Response to Astrid Kerkweg's Comments

Response to Diego Miralles's Comments

Response: Dear Diego Miralles, we thank you very much for the constructive comments and suggestions. In the following, we provide an item-by-item response to your specific comments. Your comments are written in italic black color; our responses are shown in upright font blue color.

Hourly

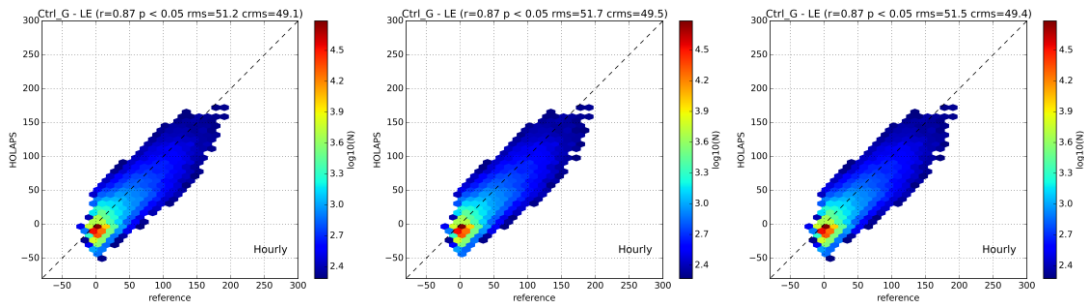
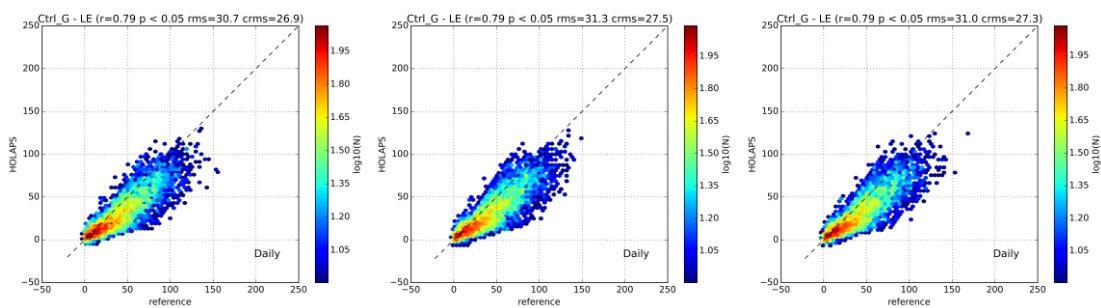
– What do you do with rainfall times in the validations? The latent heat flux measurements from eddy covariance are typically removed when it rains in this kind of comparisons (see e.g. Ershadi et al., 2014; Miralles et al., 2011; Michel et al., 2015), because of their little reliability when humidity approaches saturation (see e.g. van Dijk et al., 2015). This also means that the interception loss of the model cannot be validated through comparisons to FLUXNET data... These issues should be acknowledged somewhere.

Response: We agree that eddy covariance measurements are less reliable under rainfall conditions, like the reviewer is saying. The baseline for the comparison in the paper is, that we apply the FLUXNET quality flags and only perform comparison with data that is assumed to be of highest accuracy regarding to the FLUXNET data providers. This covers already many rainfall events.

This additional filtering did not have major impact on the comparisons. This is due to the fact, that many precipitation events are already covered by the flags already applied. The following figures show the overall LE statistics for the data with FLUXNET flags applied (left) and an additional rainfall filter for intensities of > 0.5 mm/h (middle) and > 1mm/h (right).

We have added a brief discussion on the principle need for precipitation filtering in the revised version of the manuscript.
